South Texas Project
Units 3 and 4
Docket Nos. 52-012 and 52-013
Supplemental Response to Request for Additional Information

RAI 03.07.01-27, Supplement 1

RAI 03.07.01-27, Supplement 1**QUESTION:****Follow-up Question to RAI 03.07.01-19 (STP-NRC-100093)**

Revisions to COLA Section 3H.6

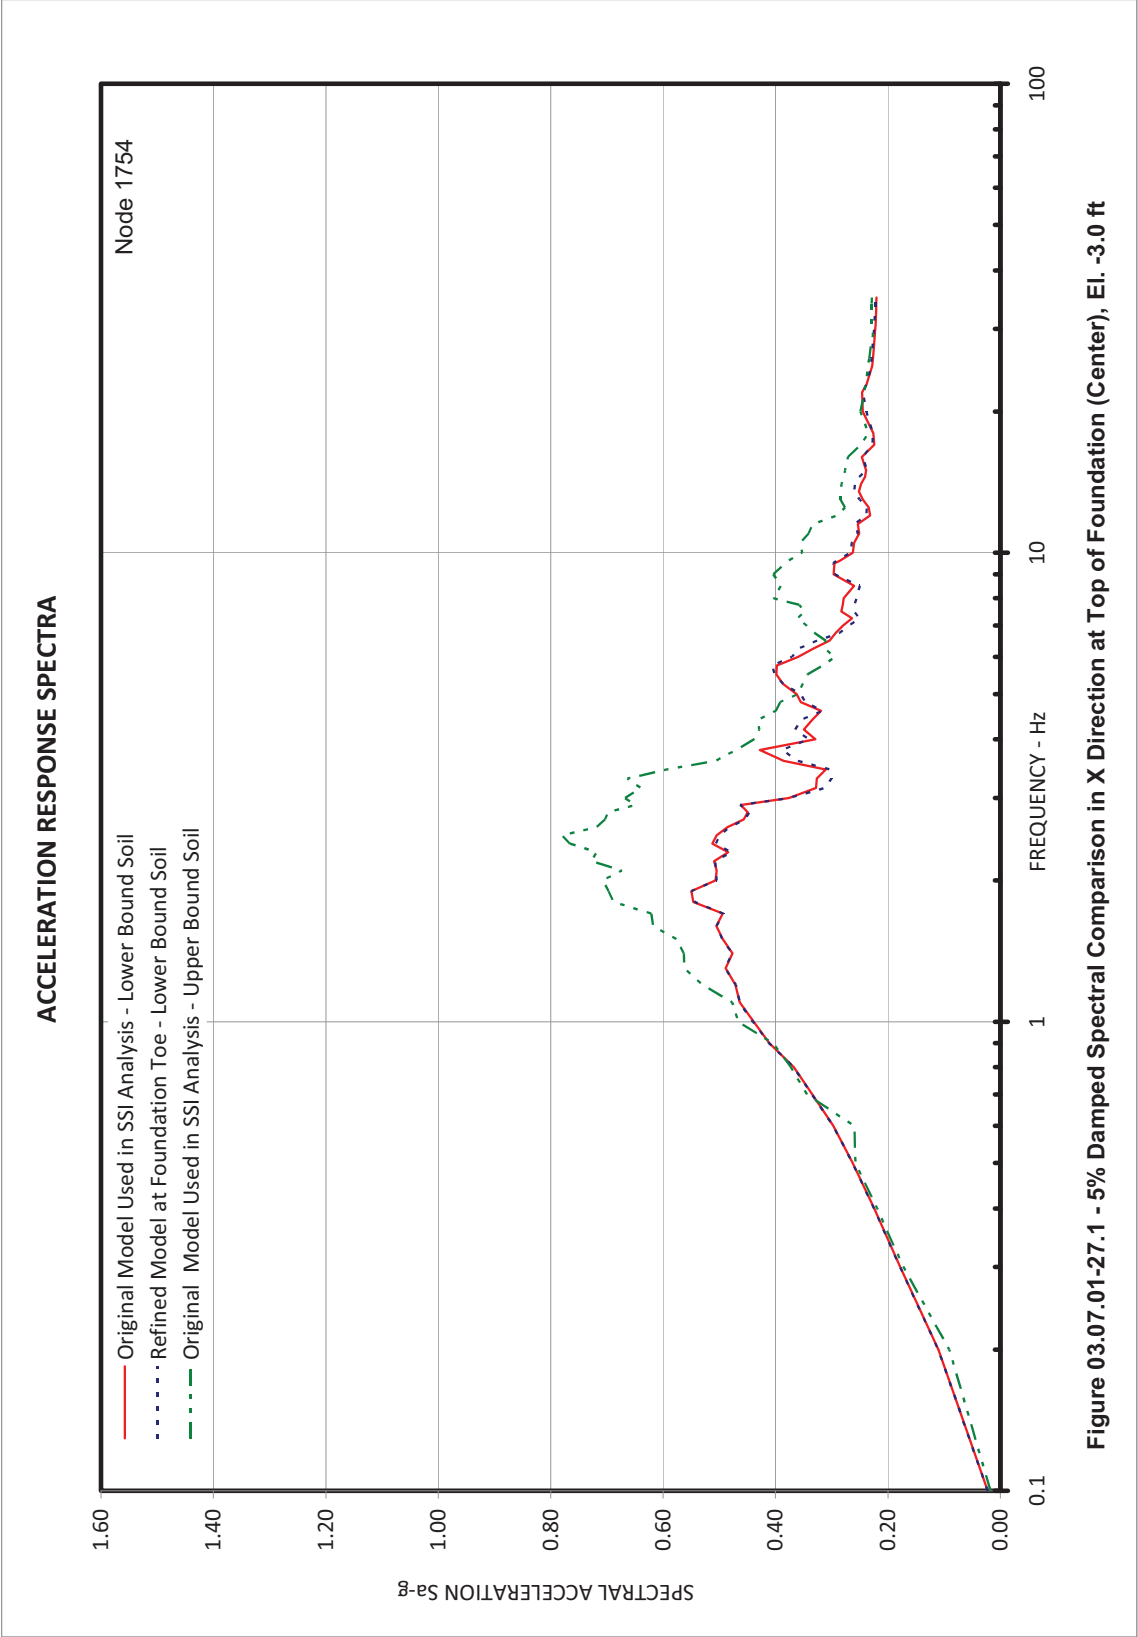
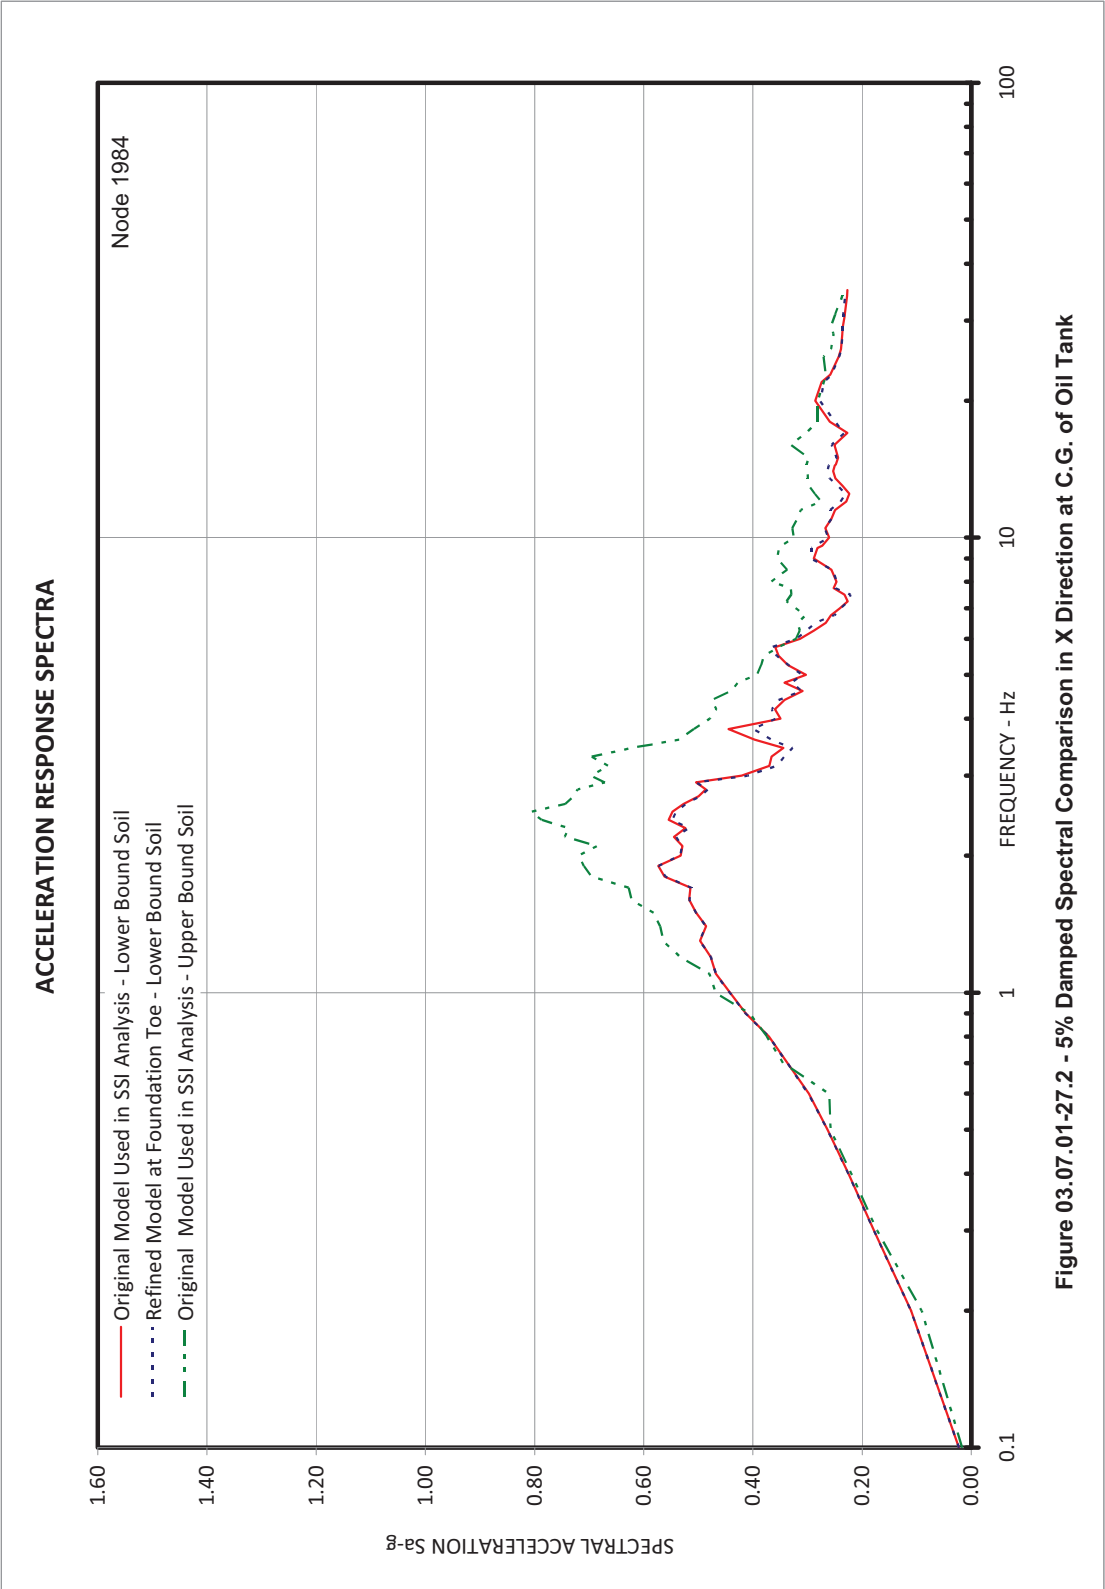
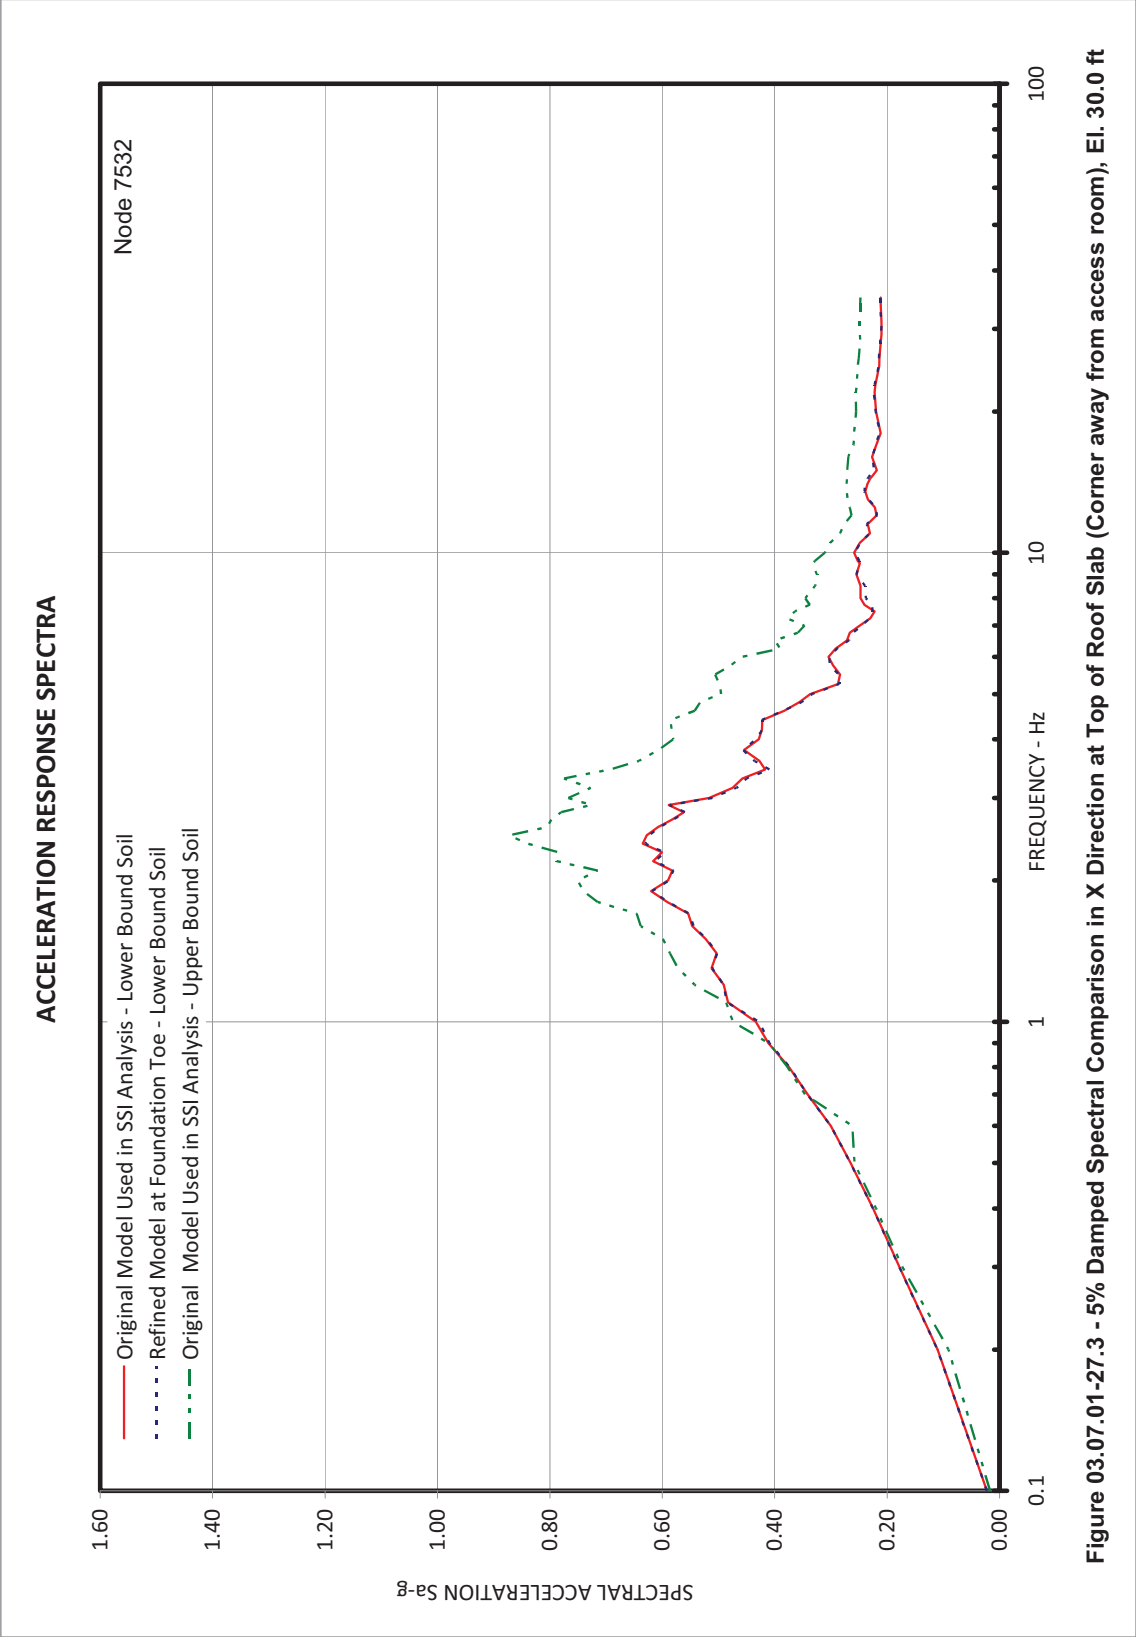
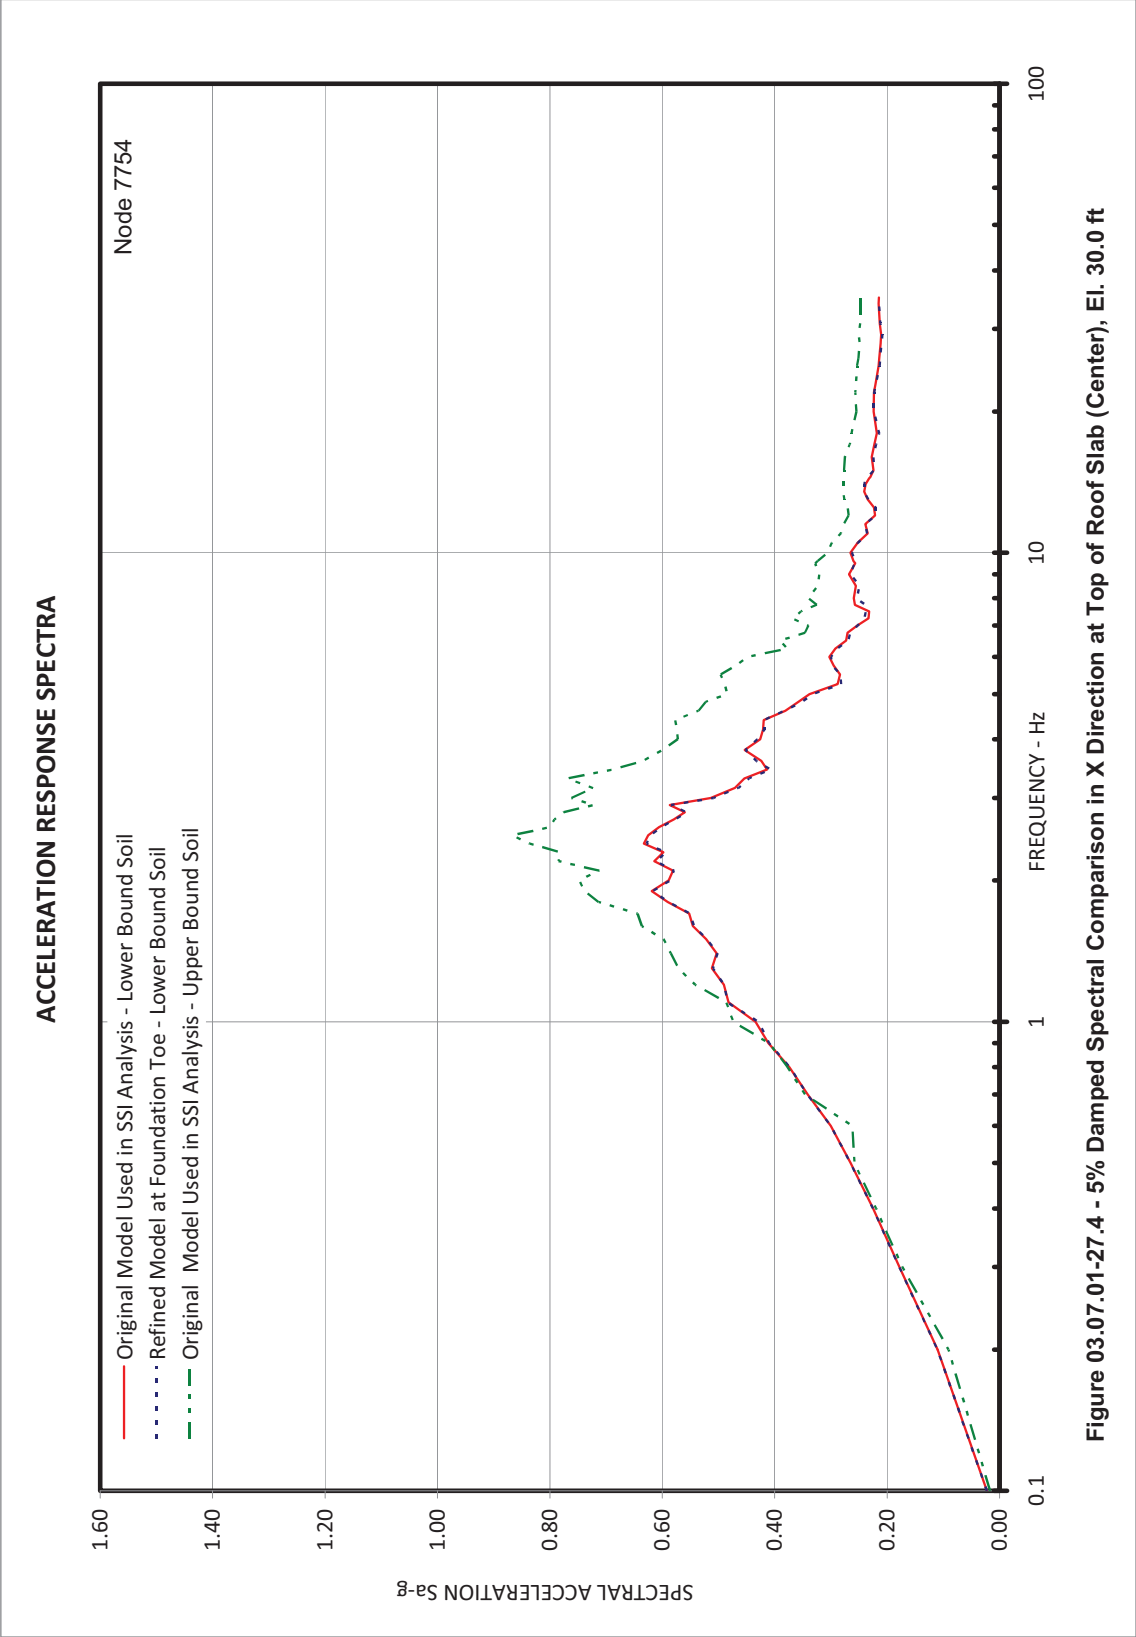
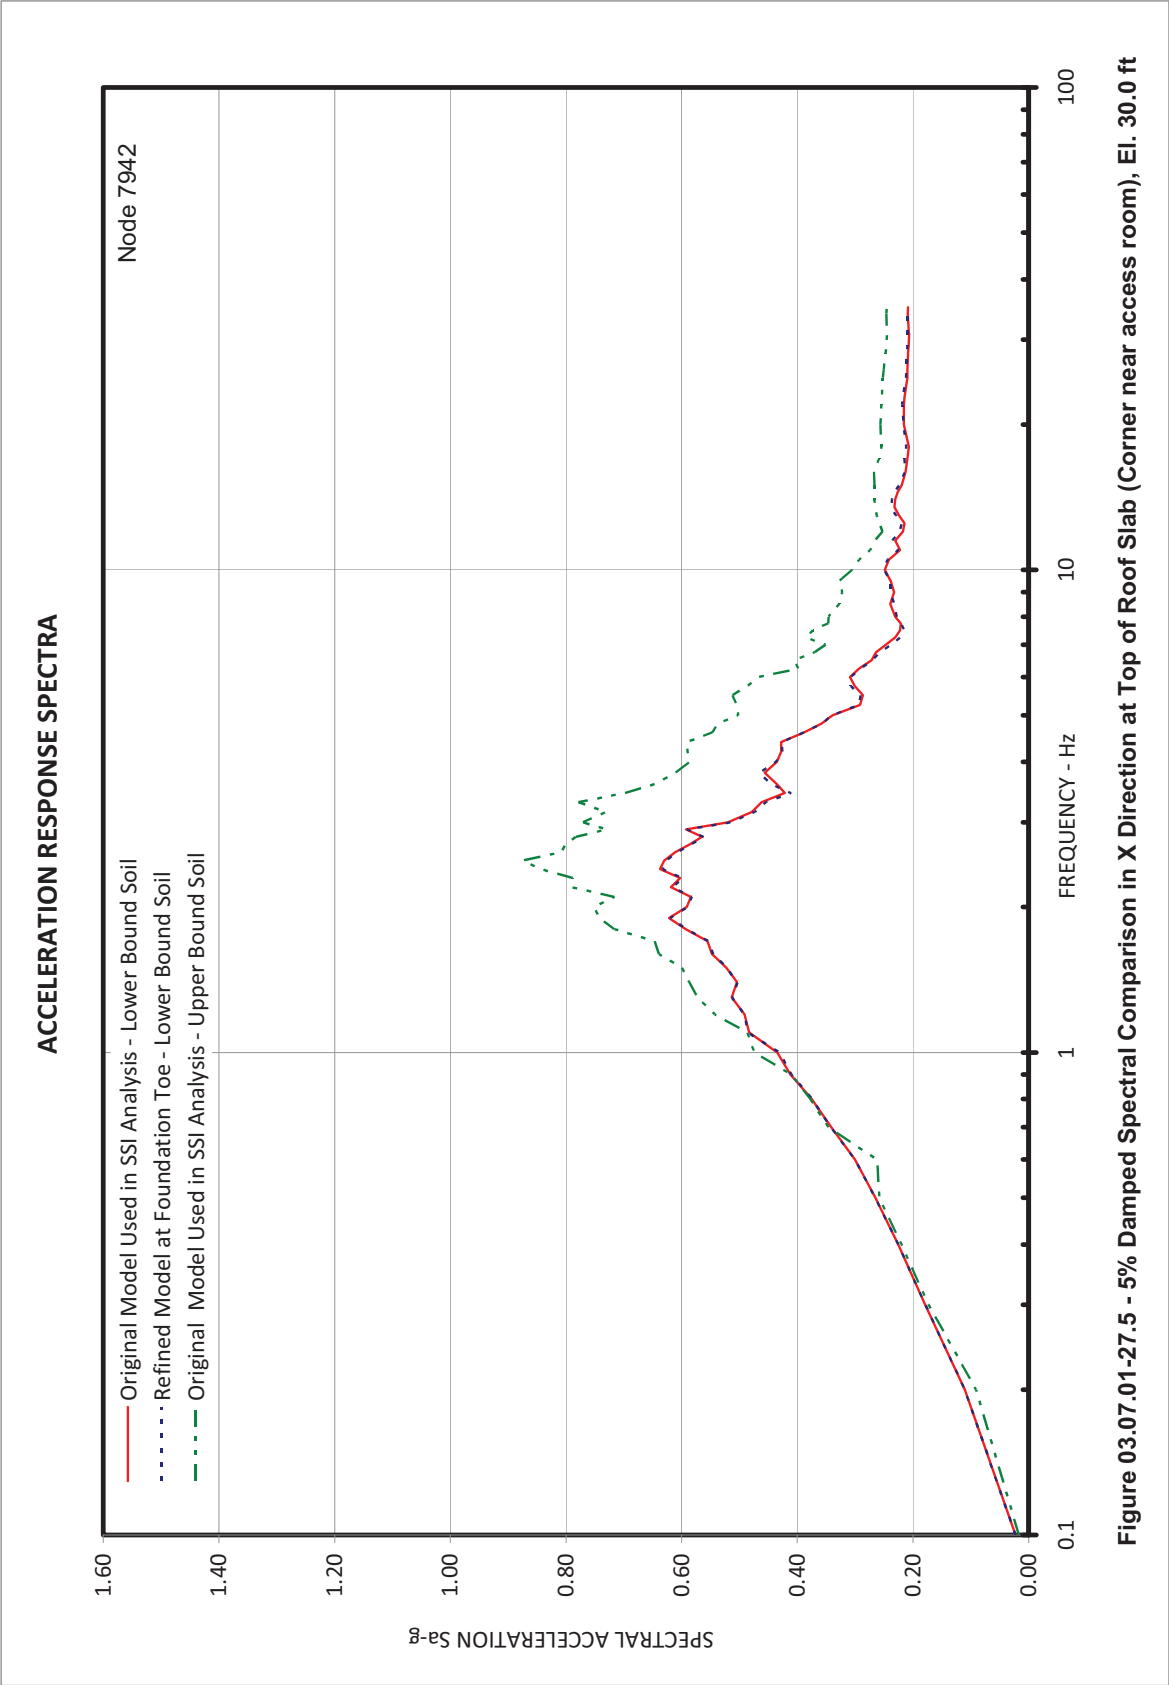
- (a) Describe in detail the method used for the SSI analysis of DGFOVS including the procedures for treatment of strain dependent backfill material properties in the model, input motion used and how it is specified in the analysis, variation of soil properties, and the computer programs used for SSI analysis.

To evaluate the effect of 20 Hz passing frequency for LB in-situ case, the foundation toe was divided into two elements, thus increasing the passing frequency to 40 Hz. This refined model with LB in-situ soil properties was analyzed and 5% damped spectra from this model were compared with the spectra from the original model with passing frequency of 20 Hz. The spectra comparison plots are shown in Figures 03.07.01-27.1 through 03.07.01-27.24. The comparison shows that:

- In the X direction, there is insignificant difference between the response spectra from the two models
- In the Y direction, the response spectra from the two models matched well except at frequency of about 3.8 Hz where the refined model produced higher spectra. However, spectra from both the models are enveloped by the spectra for UB in-situ soil case
- In the vertical direction, the spectra from the two models matched well (insignificant difference)

Based on the above evaluation it is concluded that the horizontal direction passing frequencies are acceptable.
